SAND CREEK RESTORATION

SHEET 2 OF 81

SAND CREEK RESTORATION
EARTHWORK & PHASING
PLAN

SAND CREEK RESTORATION
CHANNEL PLAN & PROFILE

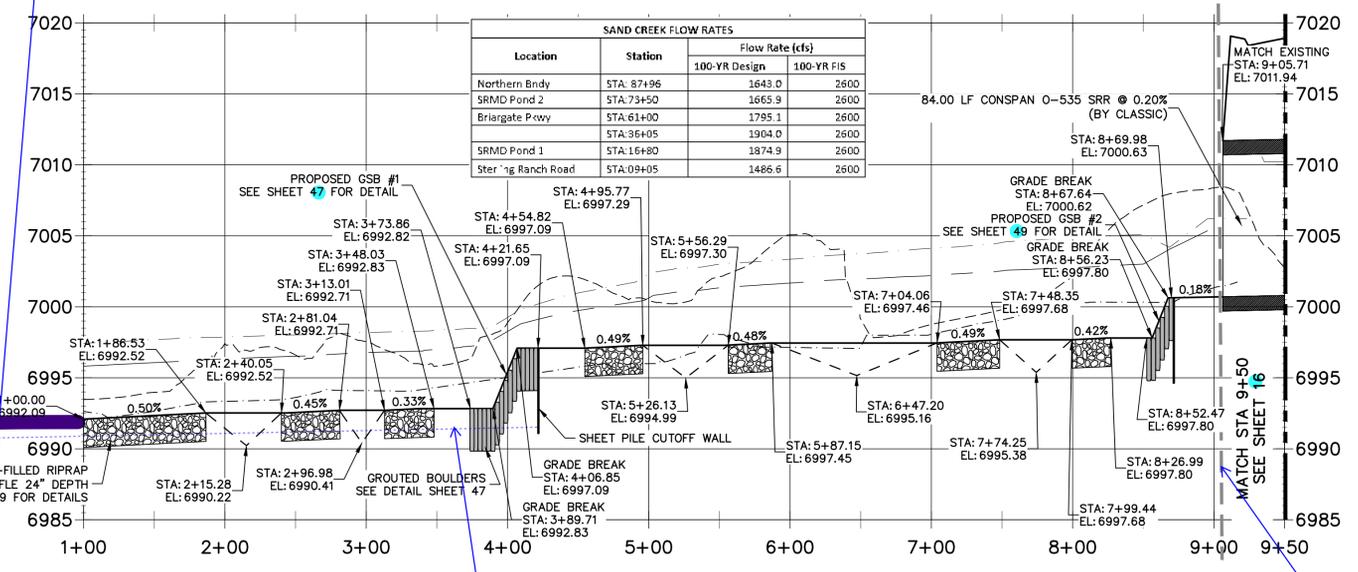
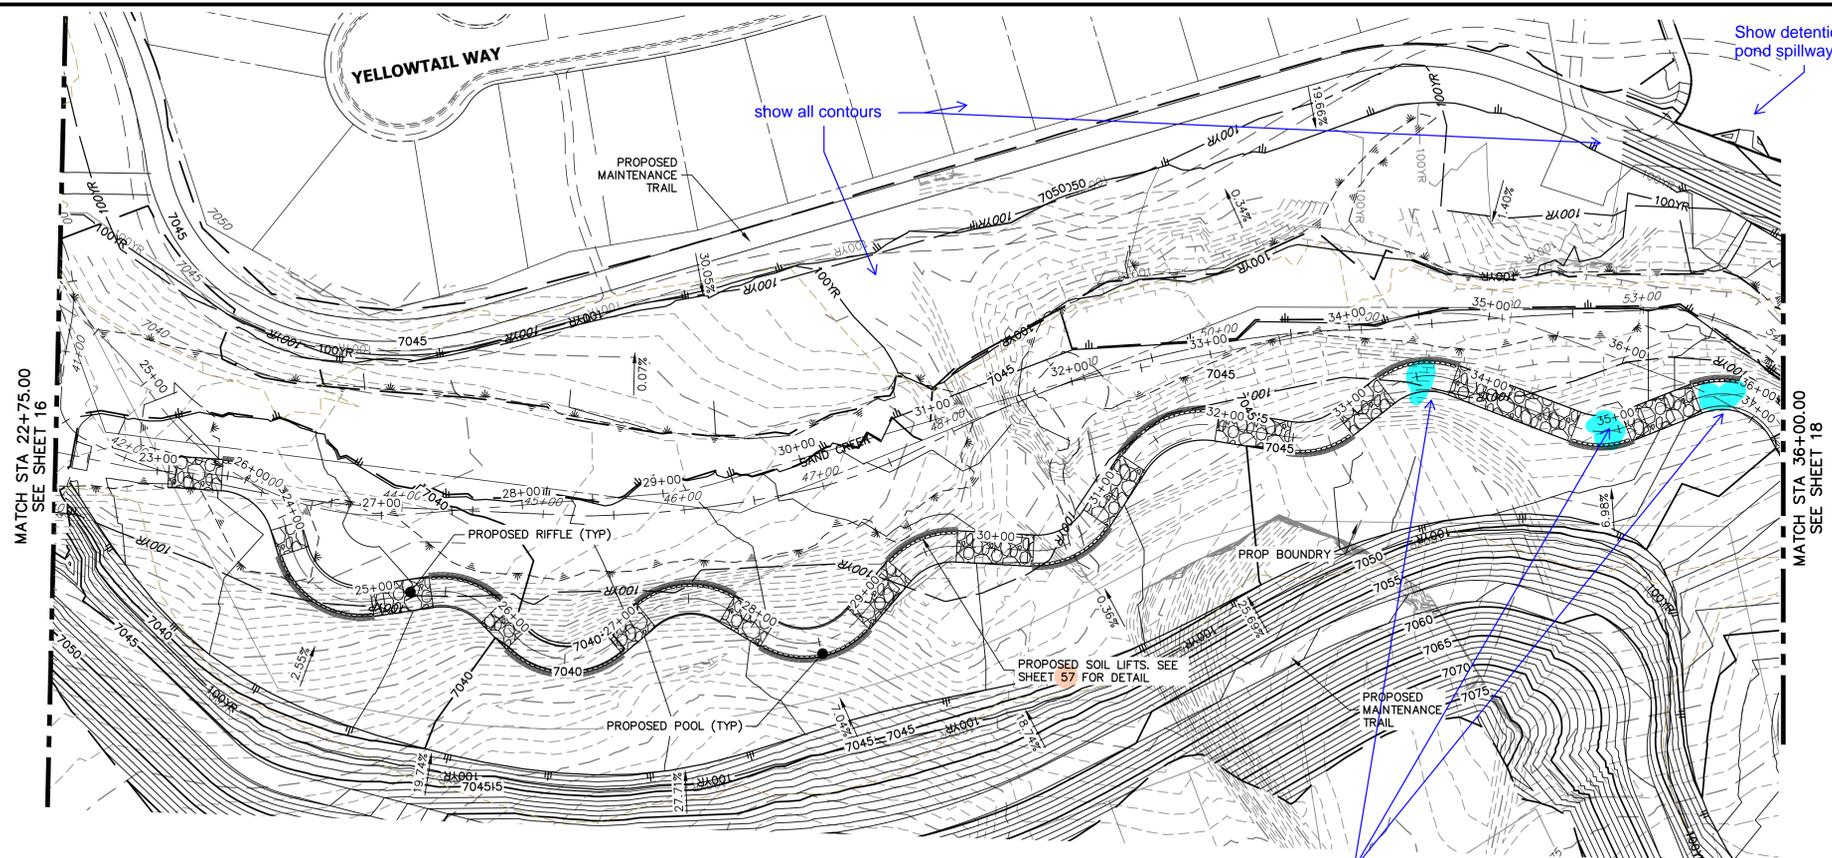
Show property line and utilities

Provide lines showing the "stable" channel grade between grade controls.

**SAND CREEK - BANKFULL PROFILE 6
STA 71+25.00 TO 88+64.00**

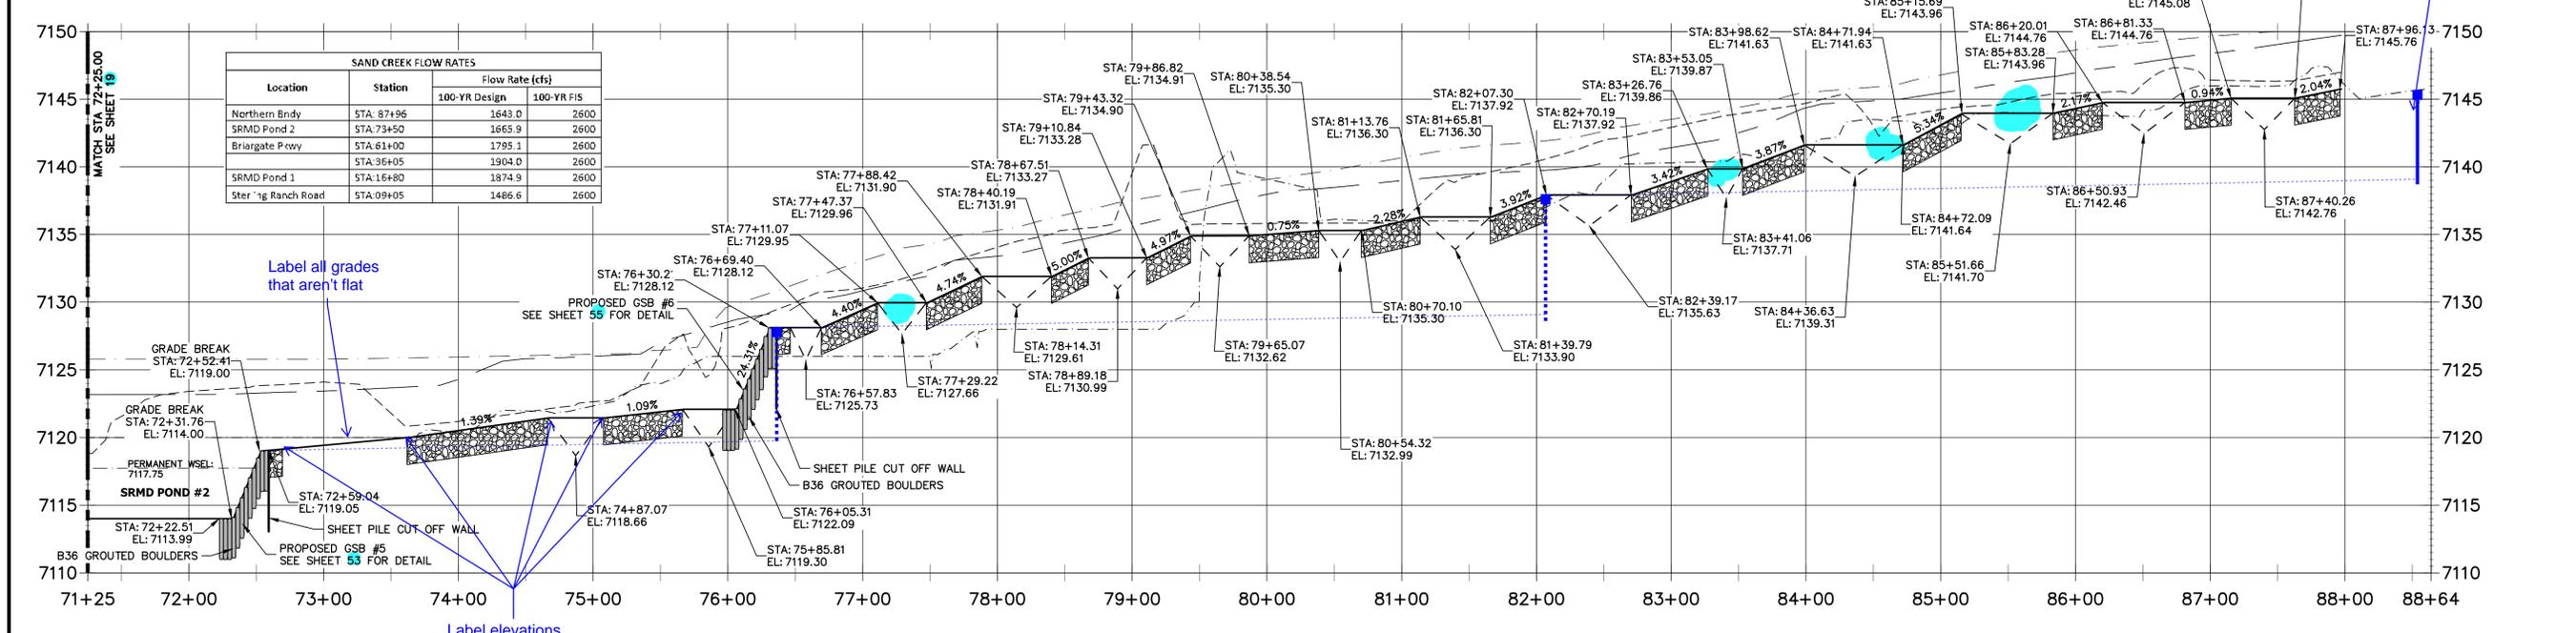
Provide plan sheet for the area to the north along Sterling Ranch or reference separate plan set

Show the existing check structure with elevations

BANKFULL CROSS SECTION – SAND CREEK
 STA: 60+00 TO 88+60
 SCALE: 1"=100'

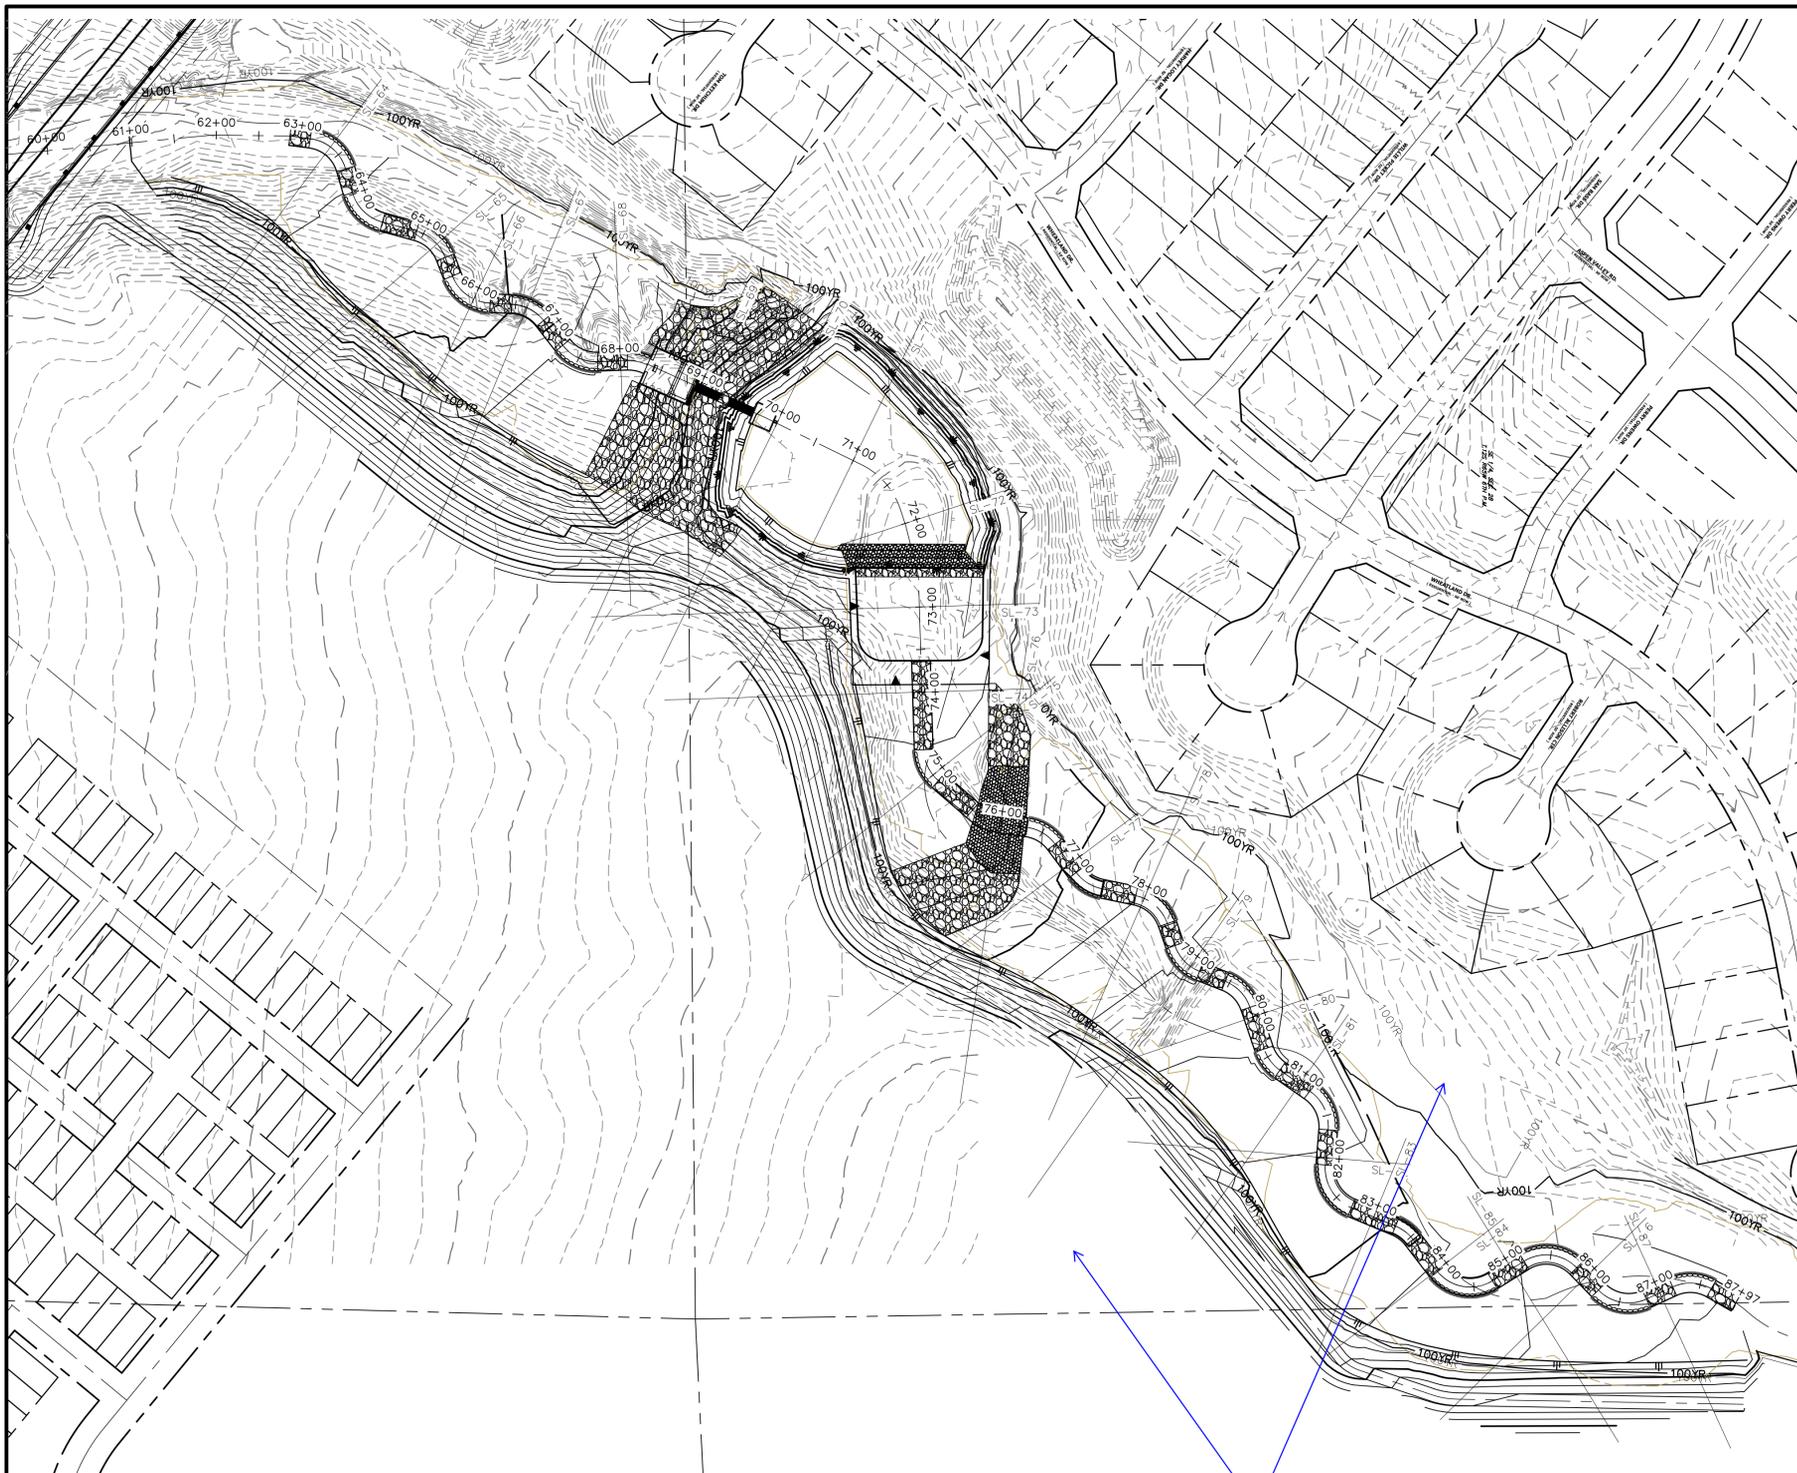
Show all contours

Prevous comment and redlines requested additional cross-sections. A lot of additional cross-sections or 2D modeling is needed to verify flow attributes.

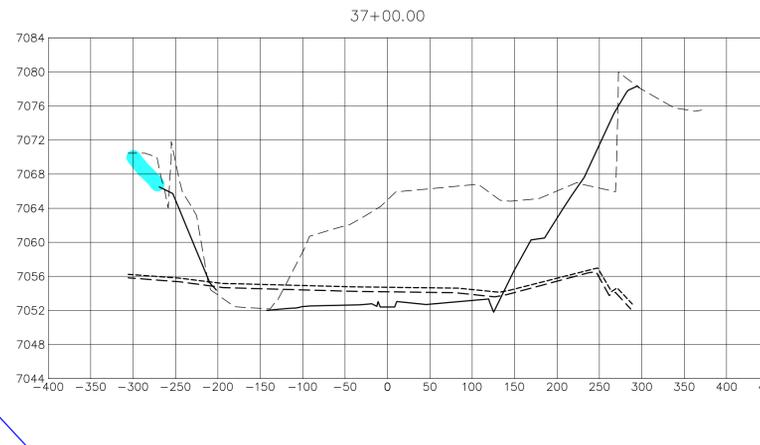
correct on all sections

Show all grading tie-ins

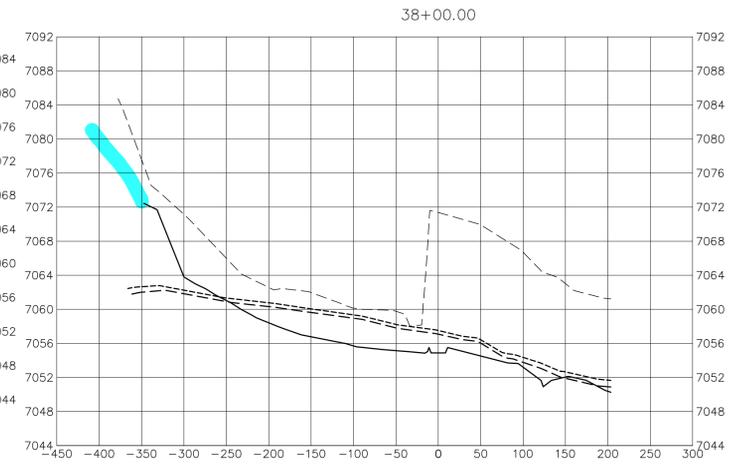
Show both maintenance roads/trail and lot lines

**STOCK POND 2 EMERGENCY SPILLWAY PROFILE
 STA 68+00.00 TO 74+00.00**

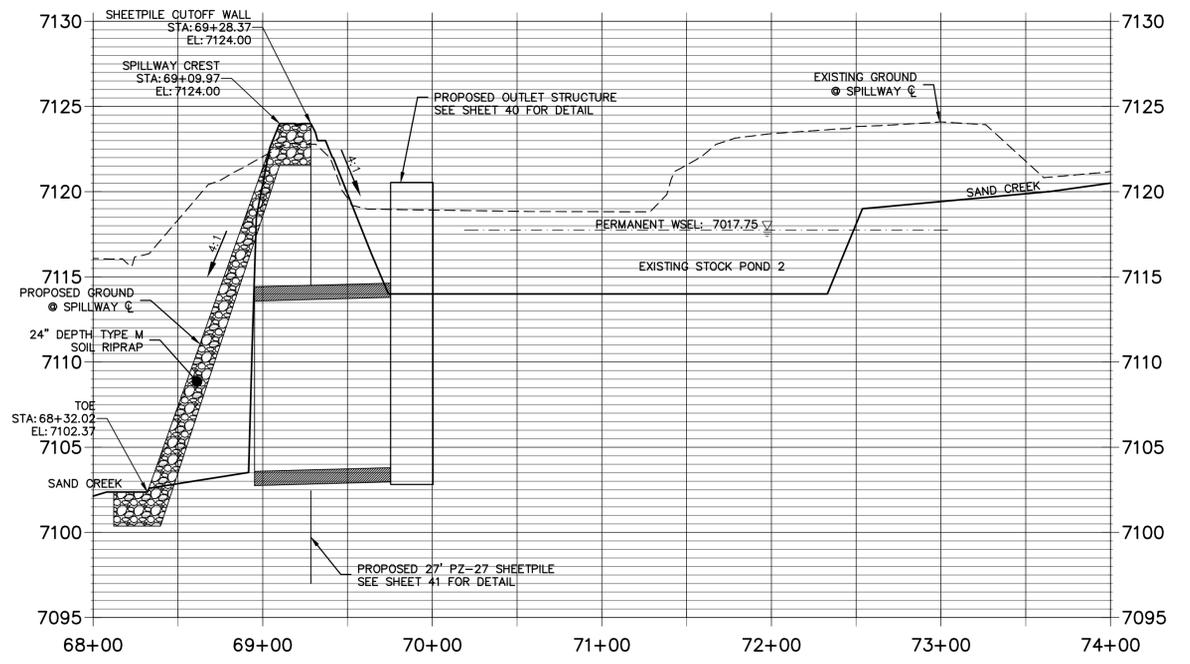
Provide complete headwall and wingwall design

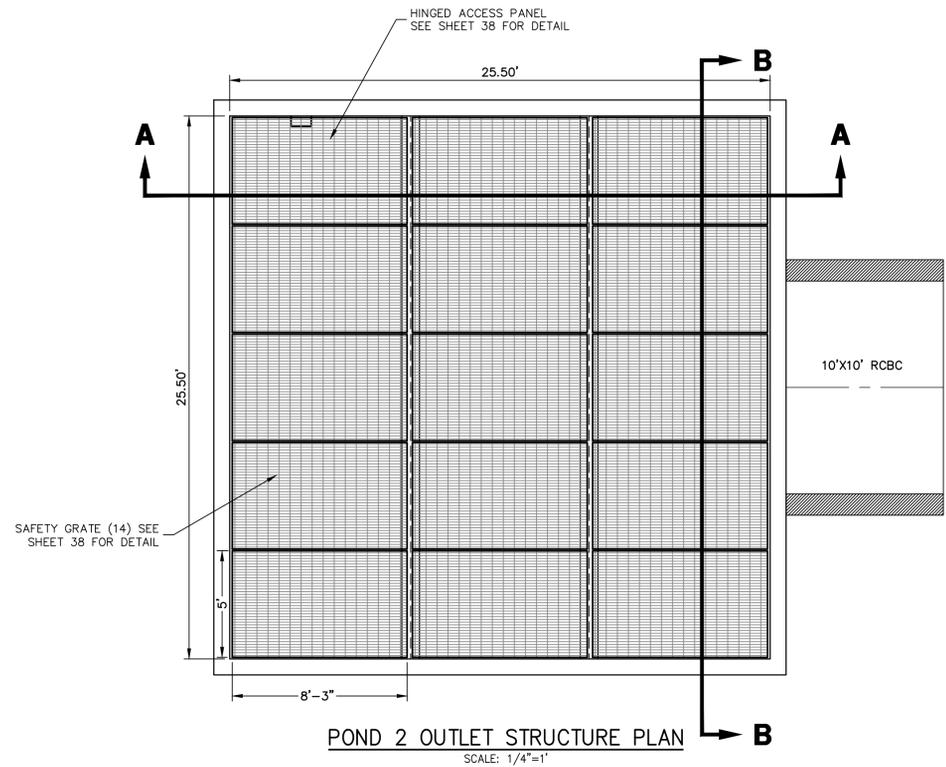
Provide complete structural design

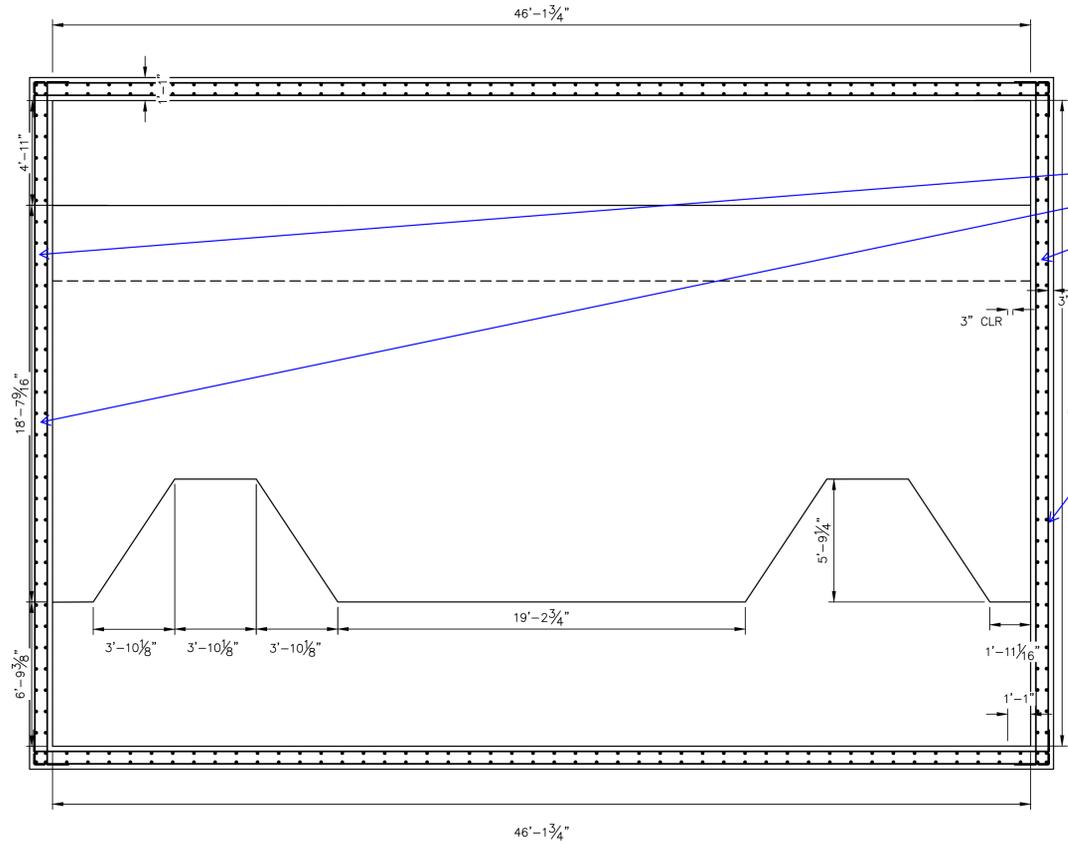
Provide details on how the baffle attaches and bending diagrams

GSB DETAIL 1
STA 2+50.00 TO 5+50.00

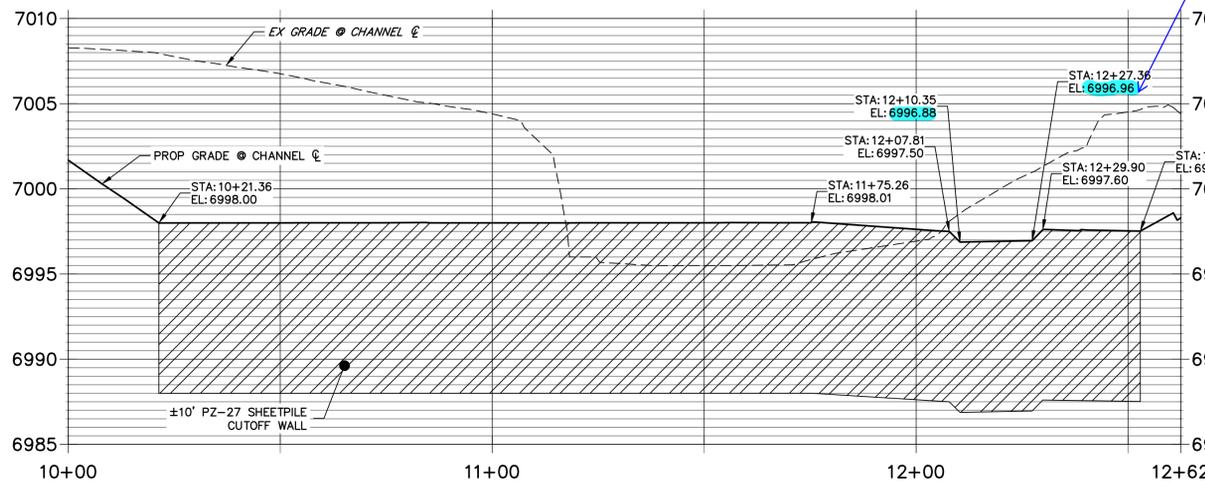
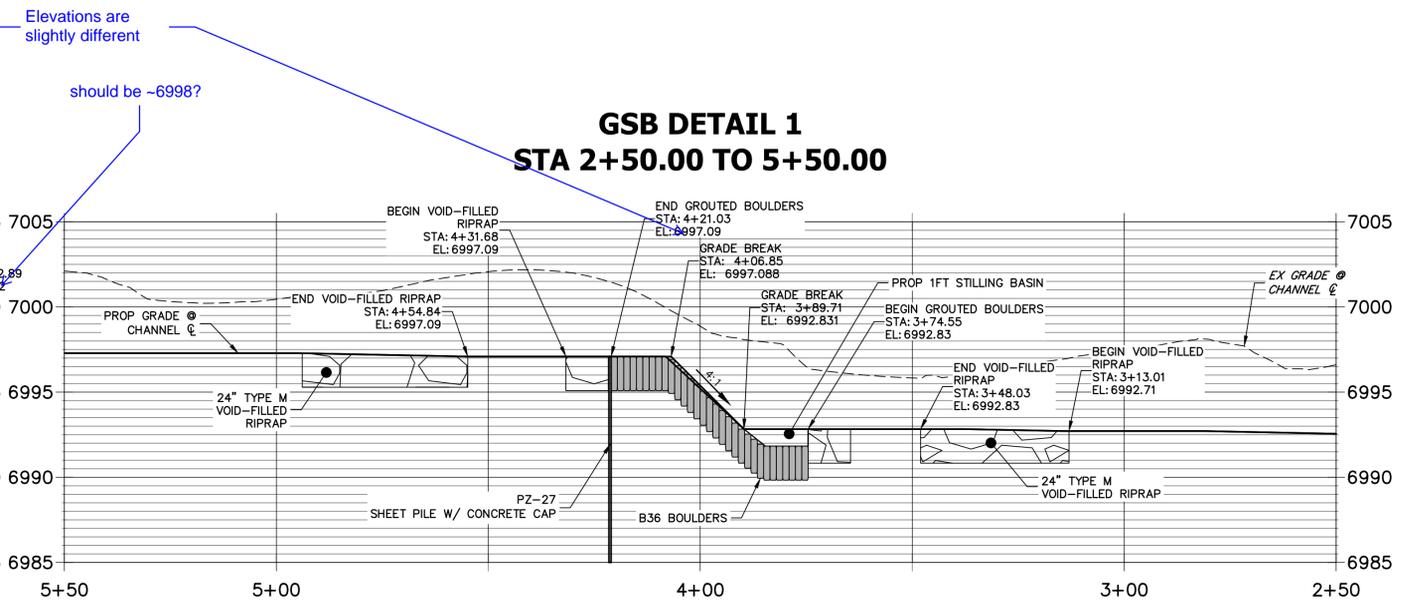
Elevations are slightly different
should be ~6998?

Add note that elevations are at top of concrete cap?
